APPLICATION NO.	FI	LING DATE	FIRST NAMED INVENTOR	ATTORNEY DOCKET NO.	CONFIRMATION NO.
10/743,940		12/23/2003	Richard C. Caponi	SPIROL/111/US	9382
2543	7590	09/11/2006		EXAMINER	
ALIX YA		TAS LLP	FERGUSON, MICHAEL P		
SUITE 140			ART UNIT	PAPER NUMBER	
HARTFOR	D, ČT 06	103	3679

Application No.	Applicant(s)				
	10/743,940	CAPONI, RICHARD C.				
Office Action Summary	Examiner	Art Unit				
	Michael P. Ferguson	3679				
The MAILING DATE of this communication appears on the cover sheet with the correspondence address Period for Reply						
A SHORTENED STATUTORY PERIOD FOR REPLY IS SET TO EXPIRE MONTH(S) OR THIRTY (30) DAYS, WHICHEVER IS LONGER, FROM THE MAILING DATE OF THIS COMMUNICATION. - Extensions of time may be available under the provisions of 37 CFR 1.136(a). In no event, however, may a reply be timely filed after SIX (6) MONTHS from the mailing date of this communication. - If NO period for reply is specified above, the maximum statutory period will apply and will expire SIX (6) MONTHS from the mailing date of this communication. - Failure to reply within the set or extended period for reply will, by statute, cause the application to become ABANDONED (35 U.S.C. § 133). Any rep

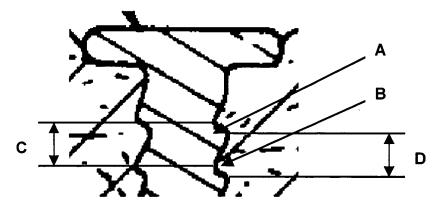
As to claim 24, Dove et al. disclose a pin 10 for insertion in a hole in a host material 22,24 and frictional engagement therein, comprising:

an elongated cylindrical body having a longitudinal axis, a cylindrical pilot portion

16 having a first diameter, and a formed portion 14 defined by a plurality of alternating
helical lands A and grooves B, each the land having a width C (Figure 4 reprinted below
with annotations) measured perpendicular to the a substantially uniform height
longitudinal axis, a majority of each land having extending above the first diameter, the
width being at least approximately five times the height,

wherein the lands are oriented at an angle of approximately 45 degrees relative to the longitudinal axis (Figures 1 and 4).

As to claim 27, Dove et al. disclose a pin 10 wherein the width C is between five and fifteen times the height.

As to claim 33, Dove et al. disclose a pin 10 wherein the grooves B have a width D measured perpendicular to the longitudinal axis and the width of the grooves is approximately equal to the width C of the lands A (Figure 4).
